UNITED STATES DISTRICT COURT  
SOUTHERN DISTRICT OF NEW YORK

**NEW YORK SMSA LIMITED PARTNERSHIP  
d/b/a VERIZON WIRELESS, and HOMELAND  
TOWERS, LLC,**

**EXPERT REBUTTAL REPORT OF BONNIE FRANSON, AICP CEP, PP**

- V1 Existing Grade and Monopole Base of Tower.**
- V2 5-Foot Elevation Above Grade.**
- V3 Measurement of Branch Area as per Sabre Industries Letter (Exhibit D).**
- V4 Cross Section Showing Revised and Actual Branching Pattern.**

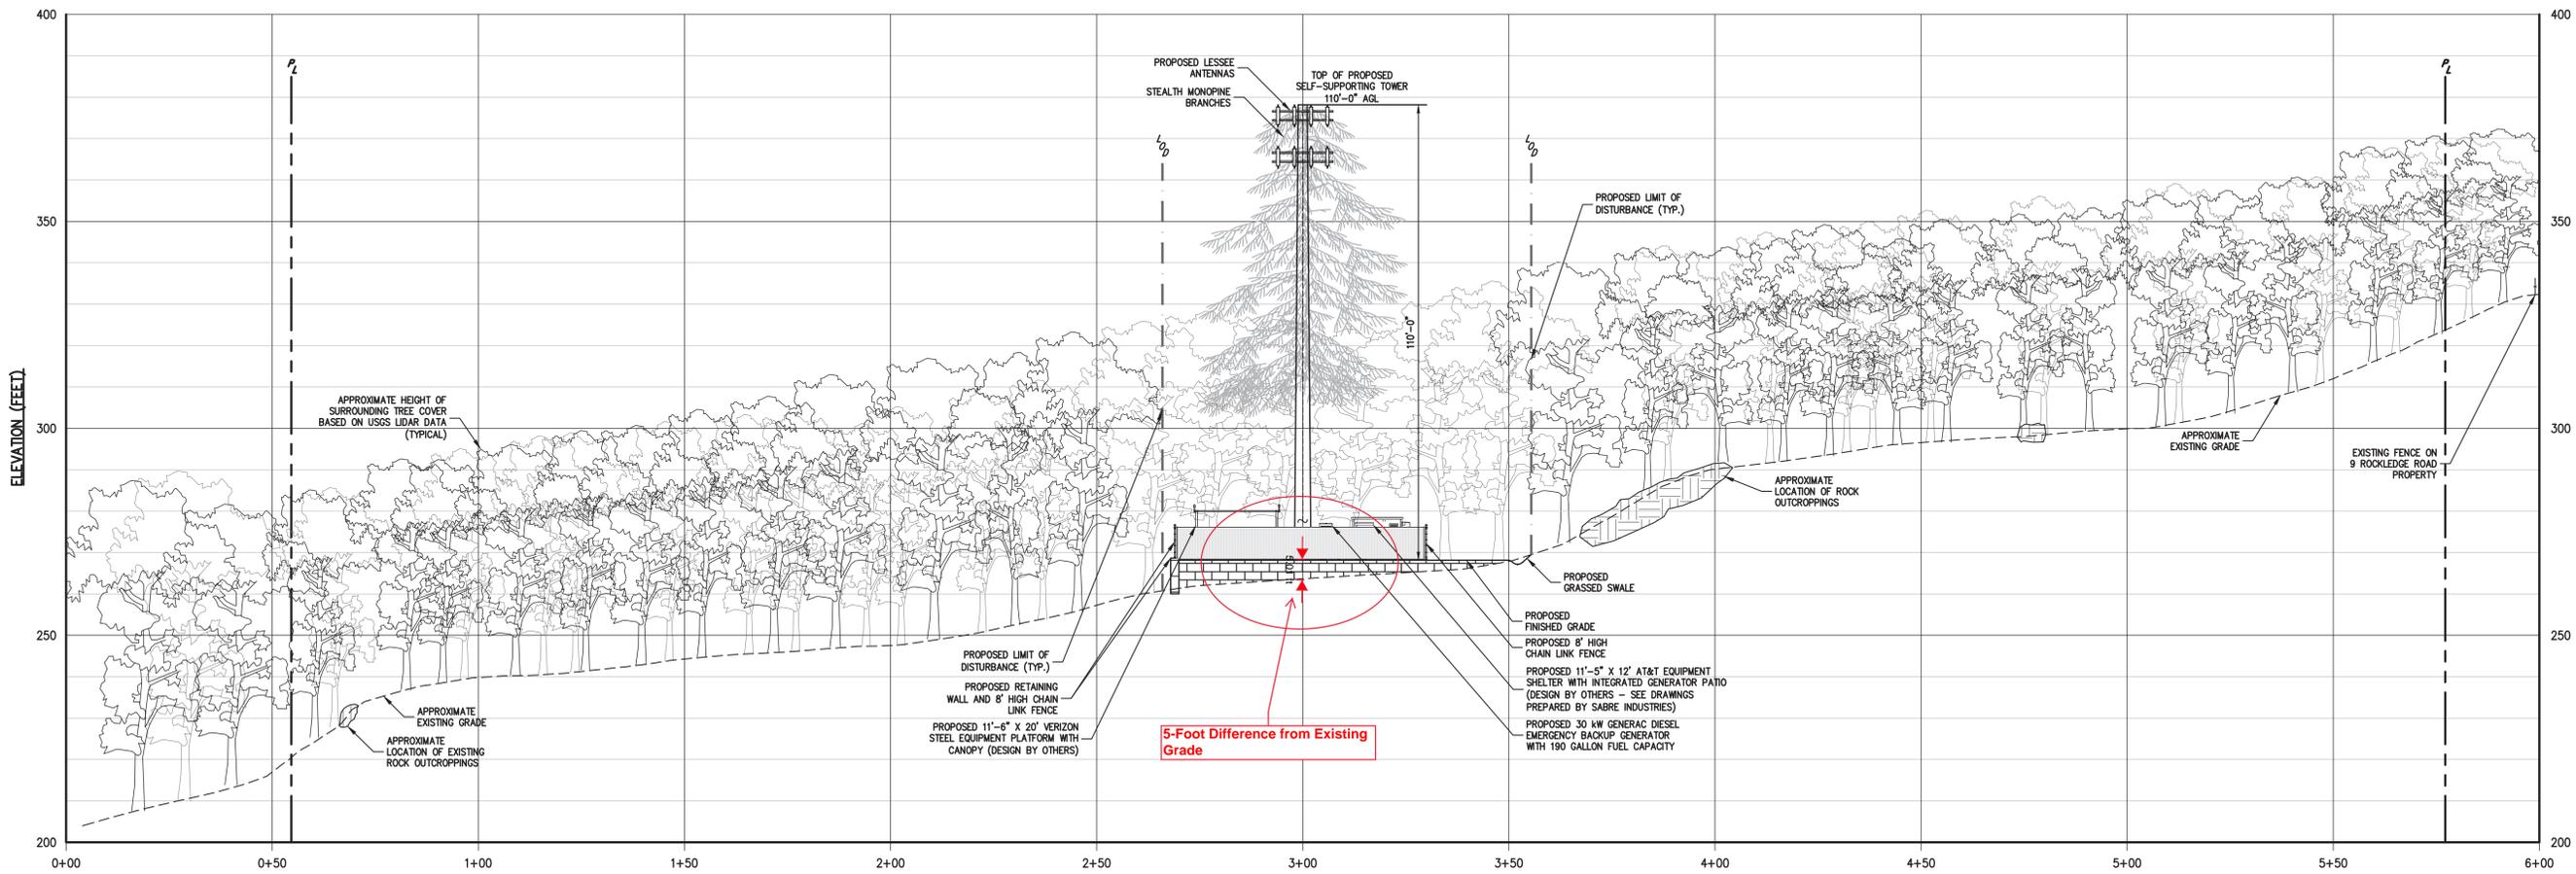
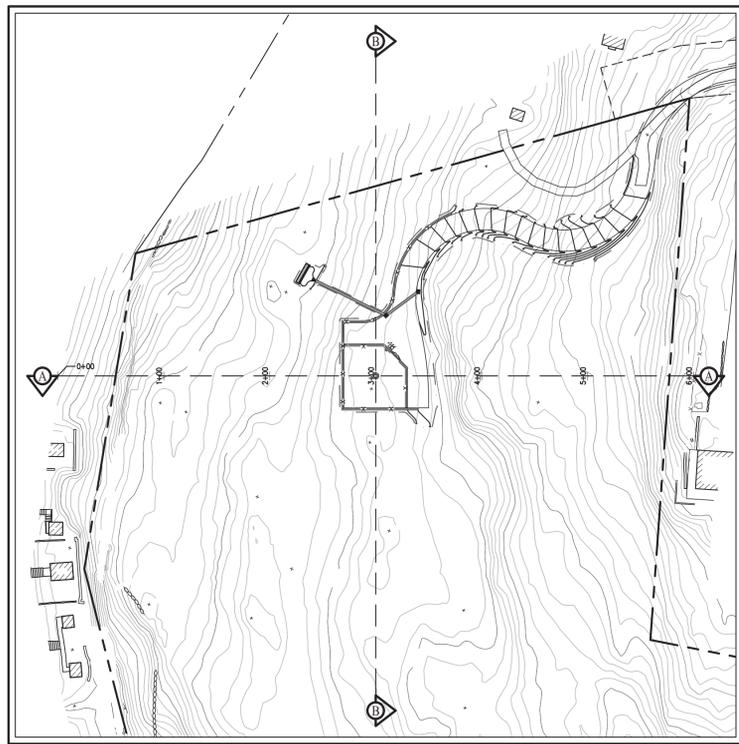
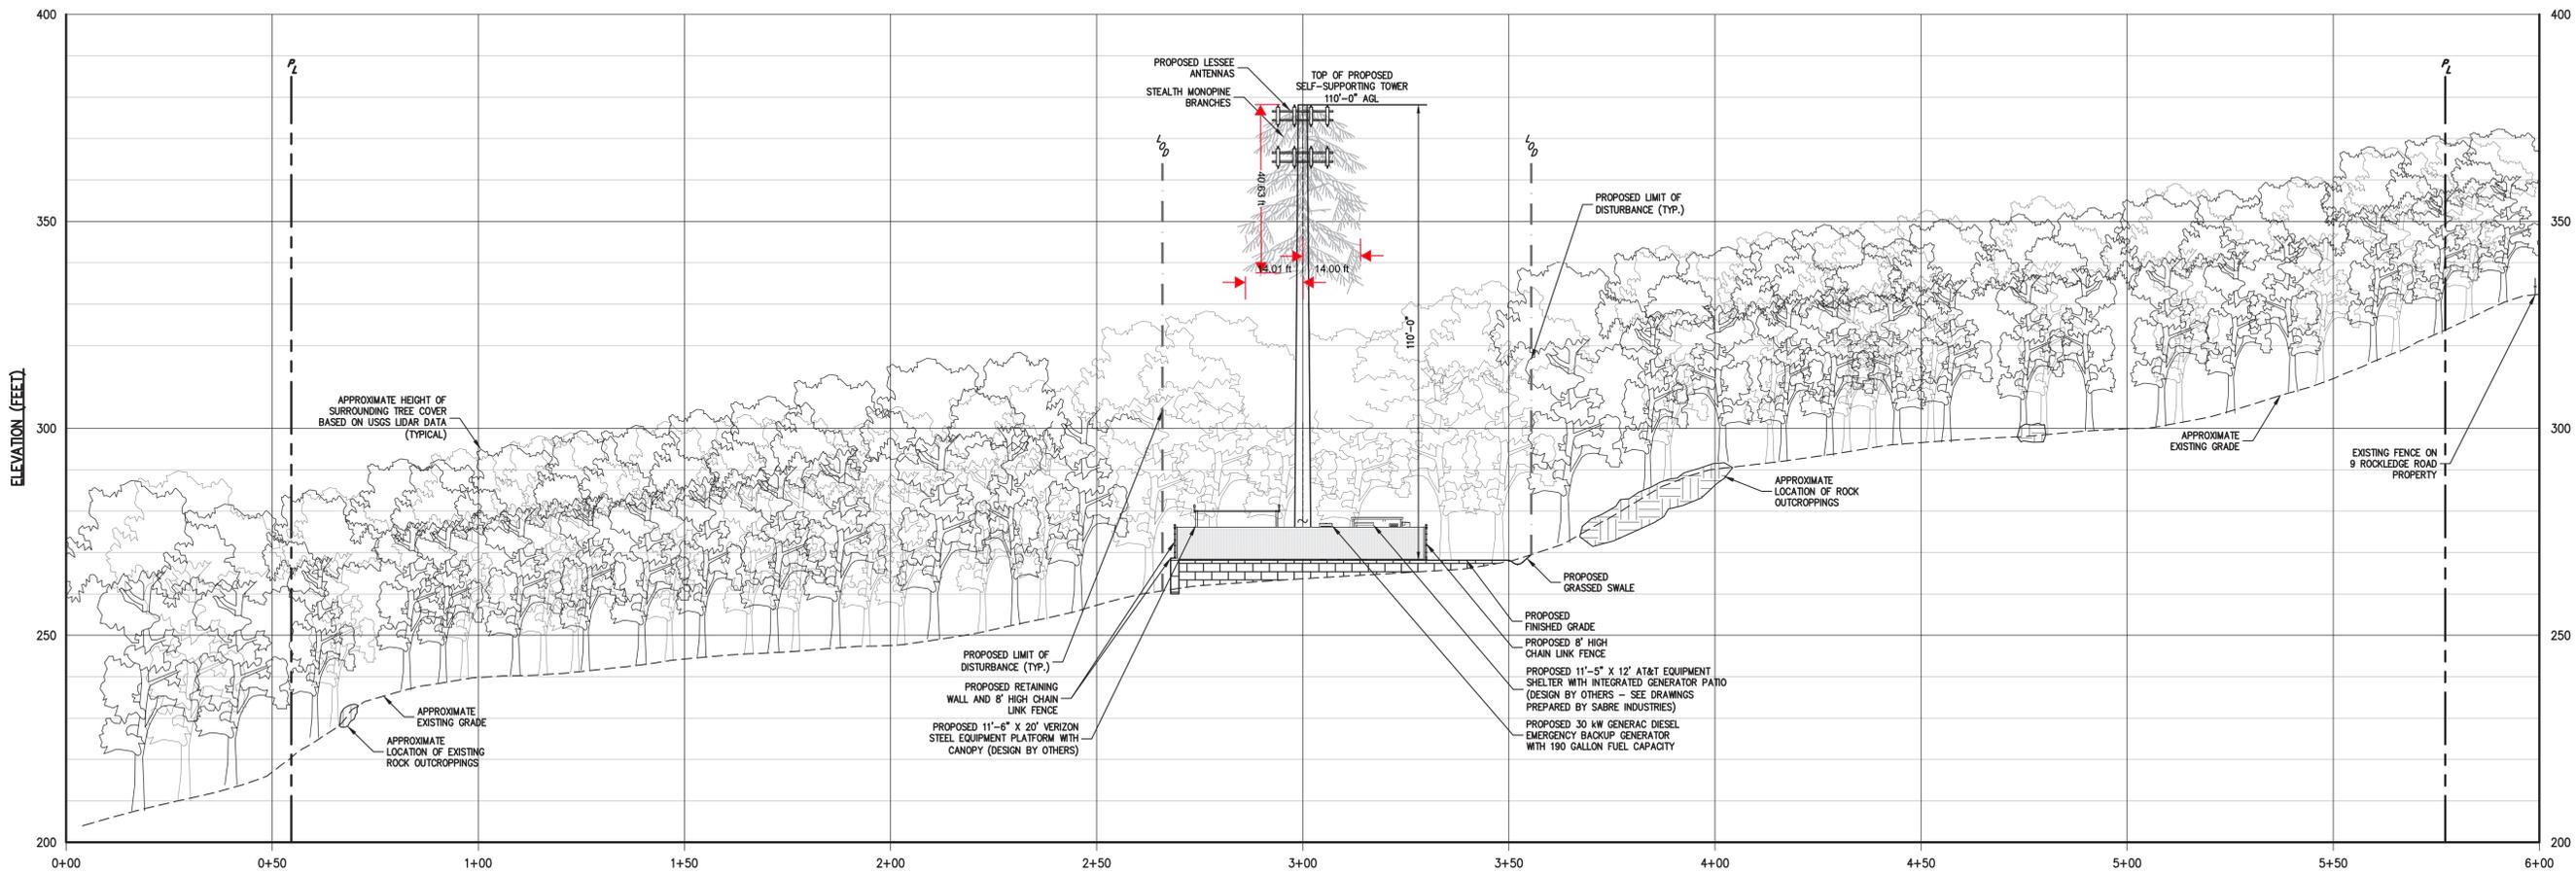
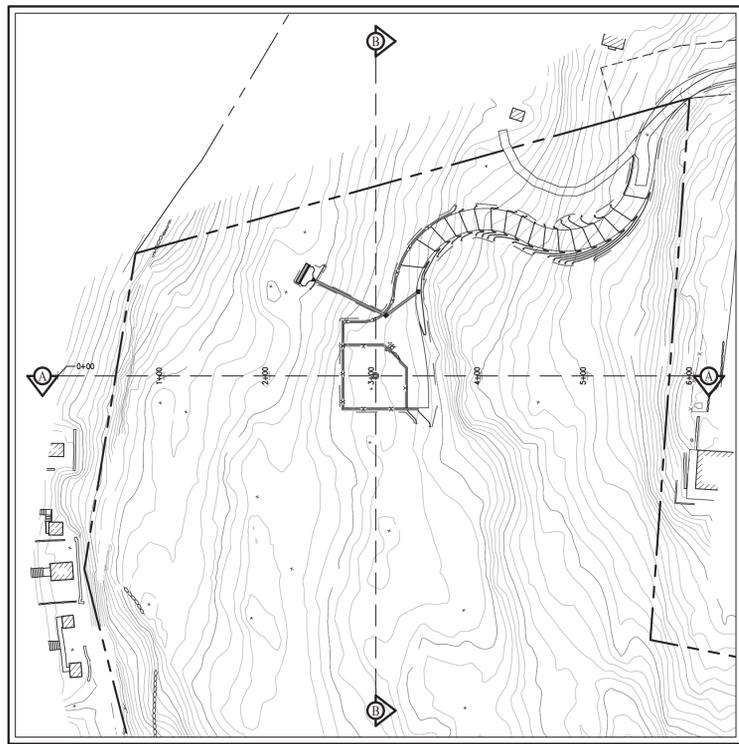
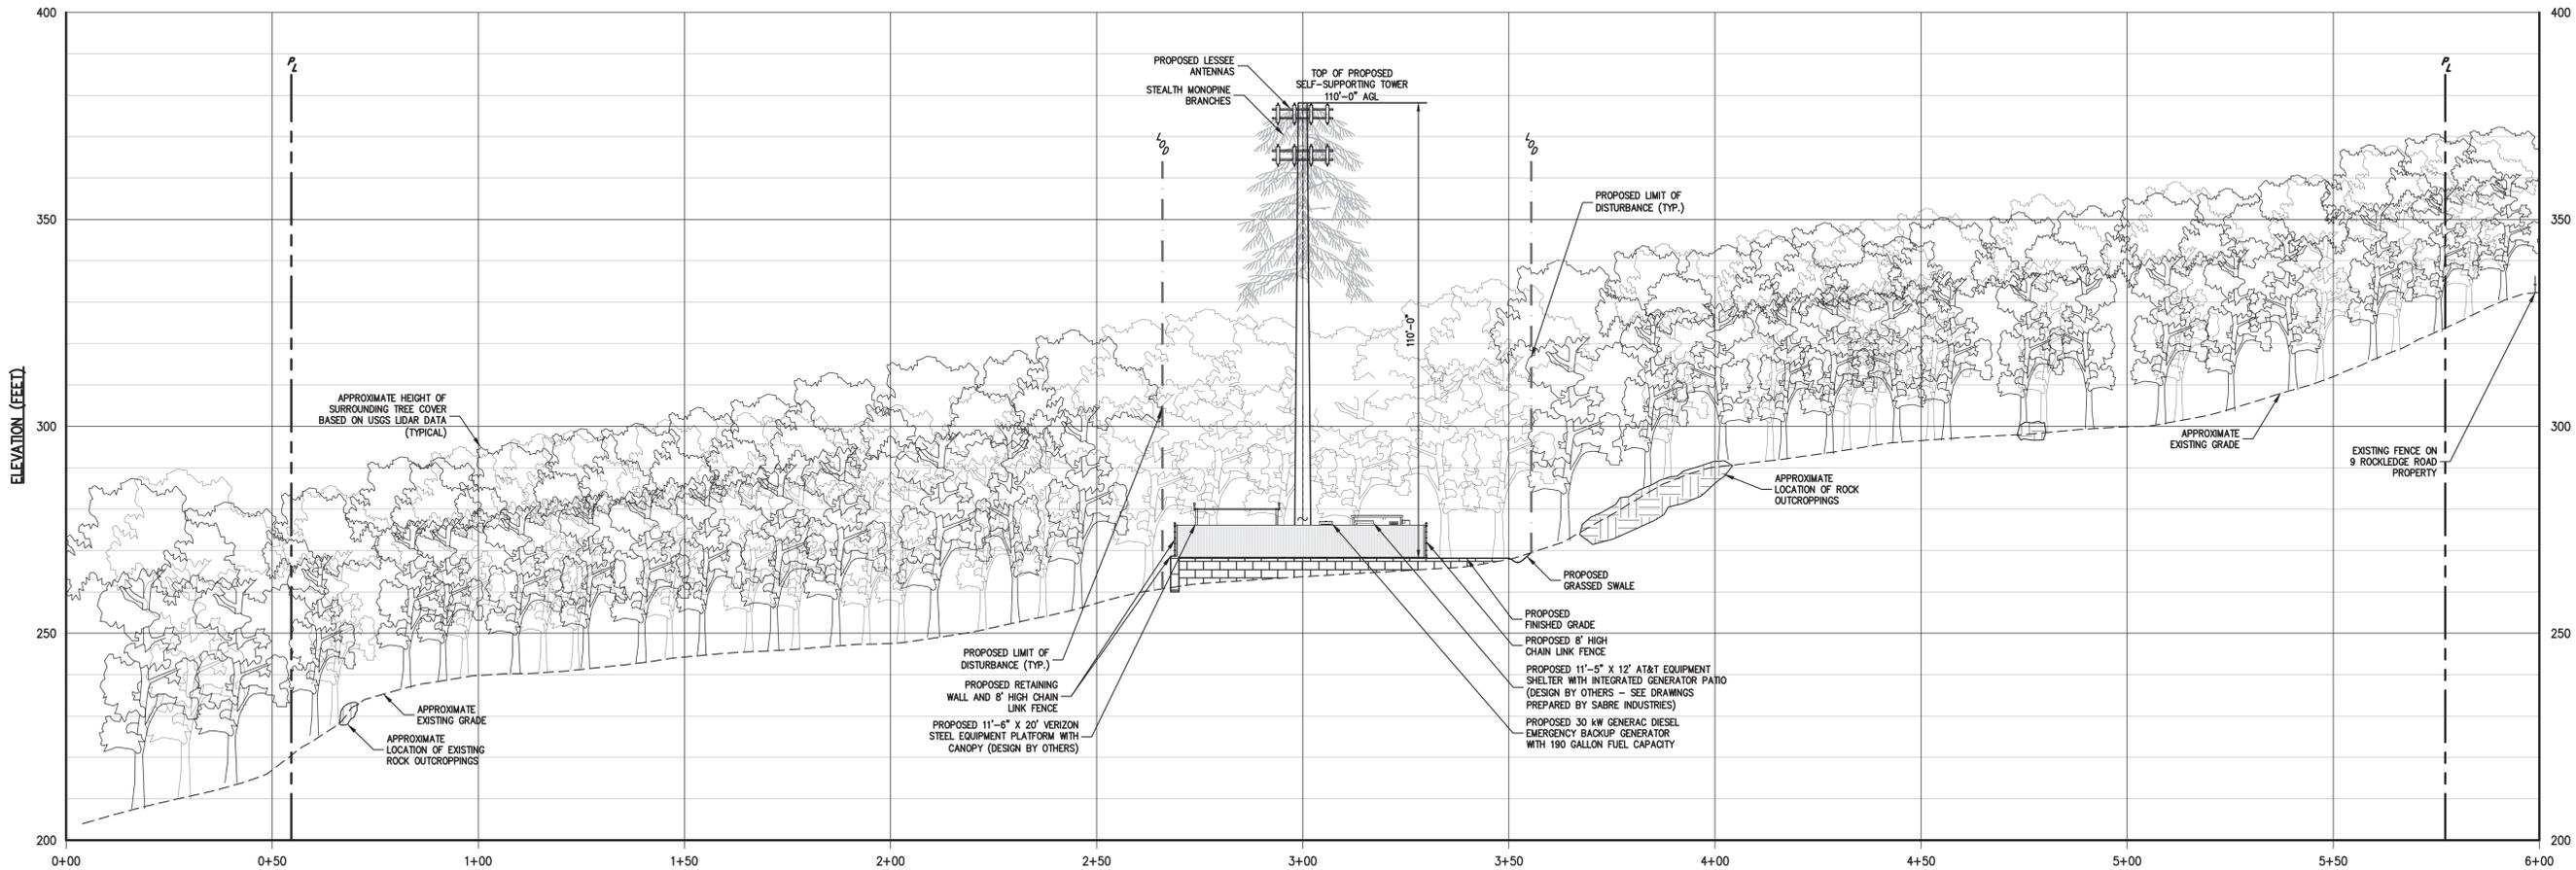
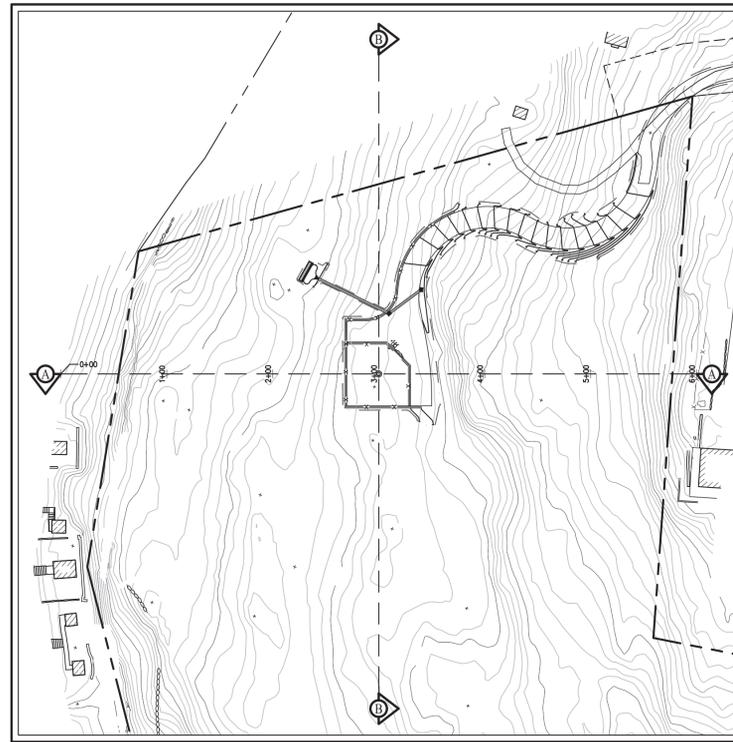
31. Importantly, the monopole will be much more visible than modeled in the Saratoga Associates June VRA and its visual addenda, and it will be readily perceived by a viewer as a man-made structure in stark contrast to the surrounding landscape when viewed from the National Register-eligible Cemetery and other vantage points, because the height of the branching is shown incorrectly. The site plan cross section prepared by JMC completely misrepresents the appearance of the cell tower, which is proposed to be camouflaged as a pine tree (referred to also as a “monopine”). The Visual Resource Assessments and the JMC report do not model the limited amount of branching that is proposed at the top of the monopile. As per the Sabre Industries letter dated September 25, 2017 (**Exhibit D**), the letter states that “Attached hereto is a branch receptor chart showing the different branch lengths, with shorter branches at the top and longer branches at the bottom of the requested branch start height. Non-uniform branch lengths will be used throughout the structure creating a non-conical or non-pyramid effect for the Monopine. The branches will range between 9' and 14' lengths and will extend from 110-ft AGL<sup>4</sup> all the way down to 70-ft AGL, which is a large area of coverage.” **Exhibit V-3** provides a measurement of the

34. Based on the foregoing, the Visual Resource Assessment does not model and accurately represent the correct tower height which should be evaluated at a height of 115 feet above existing grade, to account for the 5 feet in grade change. The Visual Resource Assessment does not model the tree removal associated with the access drive, which will remove critical backdrop against which the tower would be made less visible. The Visual Resource Assessment does not model and does not accurately reflect the visibility of the non-branch portion of the tower, wherein branches will only camouflage the uppermost portion of the “monopine” tower between 70 feet and 110 feet of the pole, leaving the base of the monopole uncamouflaged and visible, and in stark contrast to the deciduous tree line and landscape within which it is located.
